MODIFICATION INSTRUCTIONS

KODAK X-Omatic MULTILOADER 300 Plus

MODIFICATION No. 2

PURPOSE:
To upgrade the operating software to version 5.16

figure 1-2

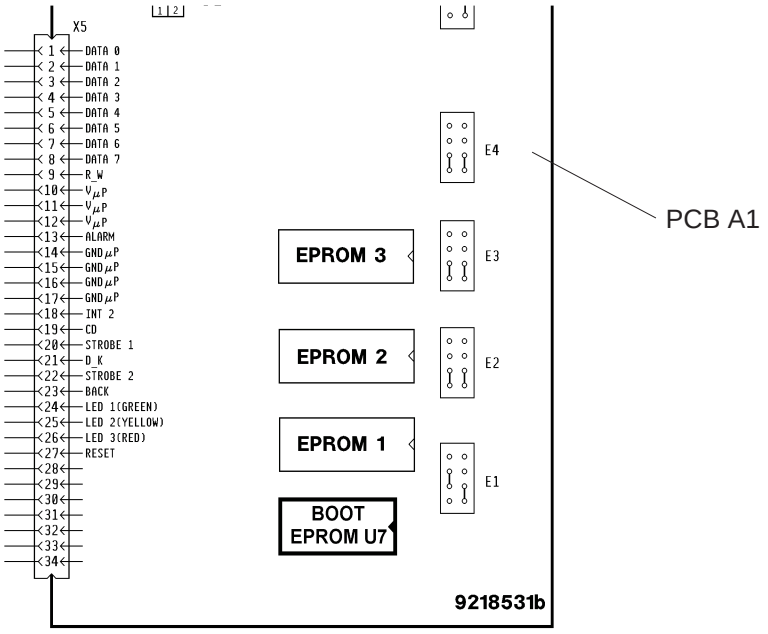
3. Do not replace BOOT EPROM on PCB A1 U7 with the new one from the MODIFICATION KIT. An already existing BOOT EROM set is used for this modification to avoid additional part numbers. In this case BOOT EPROM A1 U7 (SYSTEM UNIT) is surplus. Just discard it.

figure 1-3

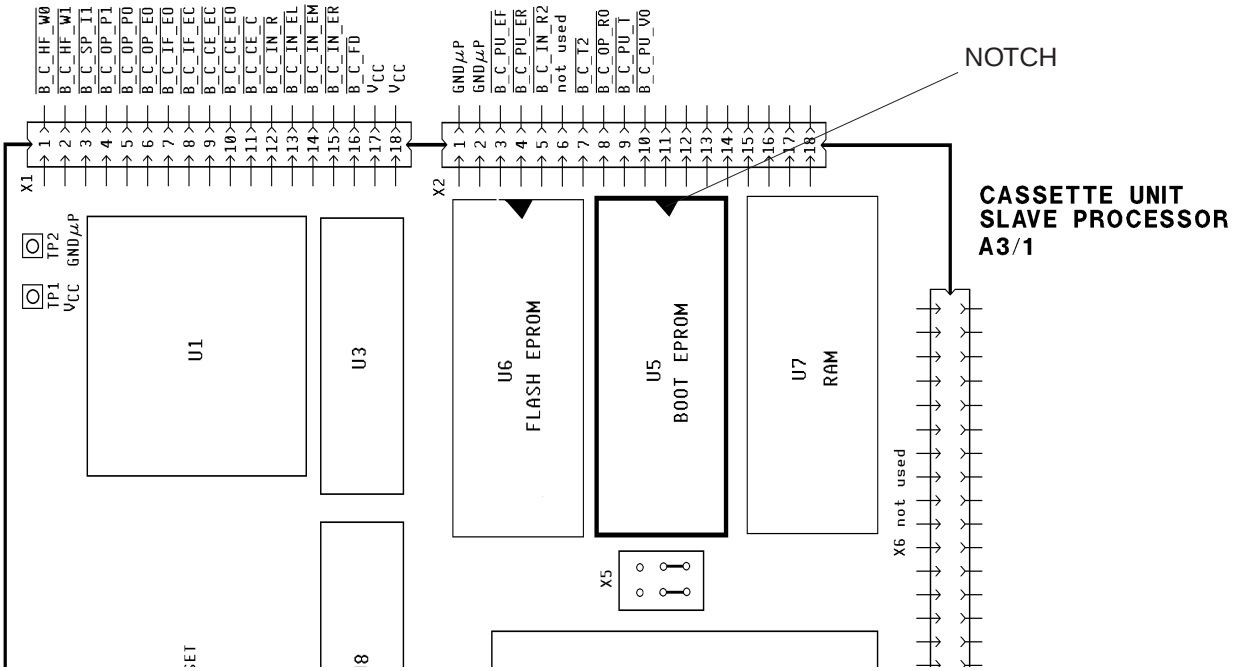
4. Replace the existing BOOT EPROM on PCB A3/1 U5 with the new one from the MODIFICATION KIT. Insert the new BOOT EPROM with the NOTCH to the right.

figure 1-4

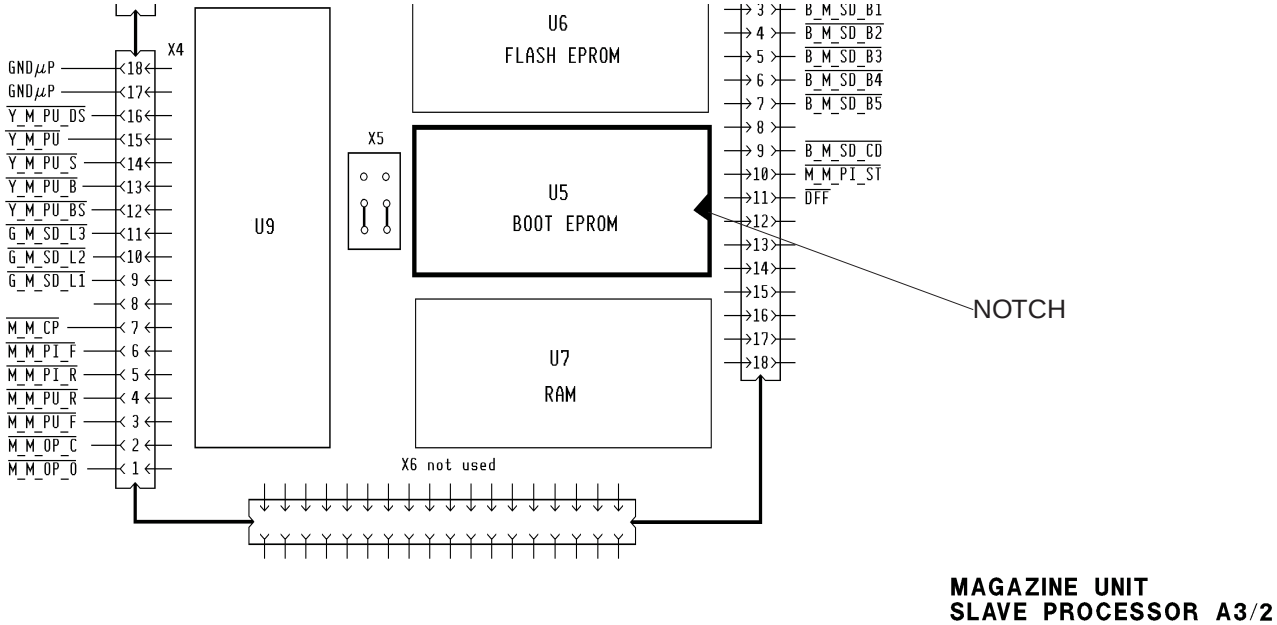
5. Replace the existing BOOT EPROM on PCB A3/2 U5 with the new one from the MODIFICATION KIT. Insert the new BOOT EPROM with the NOTCH to the right.
